PLANNING BOARD

Tuesday, July 25, 2023 at 4:30 PM
Room 24 (Basement Level) and Zoom

- i. Major Site Plan and Conditional Use; 89 Elm Street; 89 Elm Street, LLC, Applicant. The Planning Board will hold a hybrid workshop to consider Phase 1 of the Bayside Master Development Plan (MDP); a proposal to develop an eight-story mixed-use development with ground-level retail and 201 affordable dwelling units. The subject property totals 38,007 square feet, is zoned B-3 Downtown Business and R-6 Residential, and is located within the Downtown Entertainment Overlay Zone (DEOZ). A project and plan summary are available for viewing on the city's CSS Portal (<https://css.portlandmaine.gov/>) by referencing Plan Number PL-002403-2023.

- i. Major Site Plan and Conditional Use; 25 Casco Street (48 Brown Street); Developers Collaborative, LLC & Equality Community Limited Partnership, Co-Applicants. The Planning Board will hold a hybrid public hearing to consider a proposal to develop a new mixed-use building with retail space and 54 residential units at 25 Brown Street (formerly 48 Brown Street). The development triggers inclusionary zoning, with all workforce units being proposed on-site. The sub

Figure 10: Rendering of interior portion of site with building-mounted and roof-mounted mechanical equipment

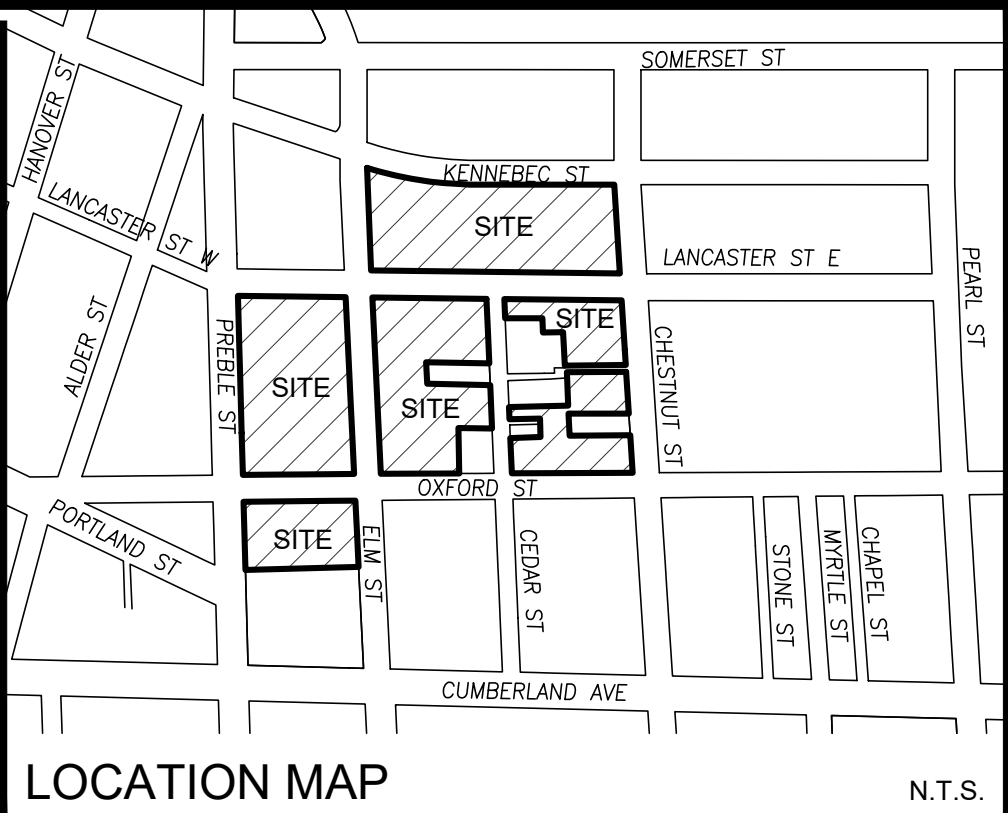
Staff Comment: Based on the proposed setbacks and massing, the proposed building will not impact the health or safety of abutting structures or result in unsafe wind conditions for occupants & visitors to the site. The proposed design of the building and continuation of the adjacent parcel for surface parking would continue to allow the neighboring residential properties to continue their use without diminution. As shown in **Figure 10**, the submitted renderings do not demonstrate how exhaust would be directed from adjacent residential properties from wall-mounted HVAC units or what screening techniques would be utilized for the

Figure 12: Gateway element at the corner of Elm & Oxford Street

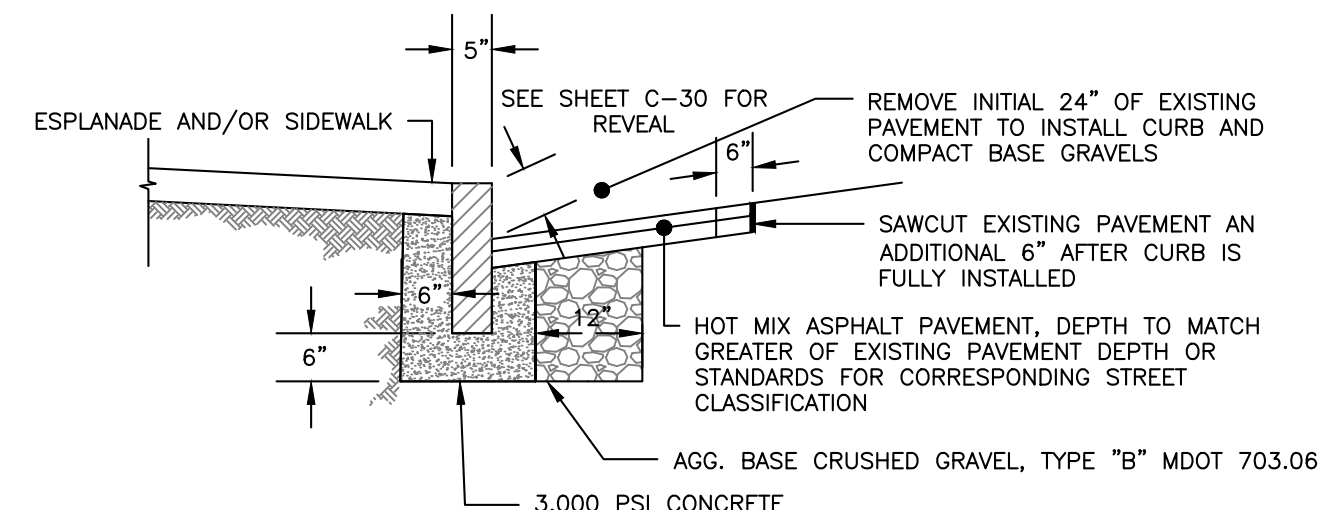
As shown in **Figure 12**, some illustrative signage has been included as part of the landscape plan renderings for a monument sign in the City right-of-way, as well as blade signs along Lancaster Street for the two retail units.

Staff comment: The resubmitted plans for the proposed development include pedestrian amenities for bench seating, trash receptacles, and signage, staff finds the proposed wood seat top insert (detail 08 tree well type 3 / L3) Elm & Lancaster Street is not appropriate within the City's right-of-way due to maintenance concerns. Staff recommends a honed finish for comfortable seating. In addition, Staff finds the gateway sign at Elm and Oxford Street is restricted within the public right-of-way per LUC 20.6.1, staff recommends a building-mounted sign as the gateway sign.
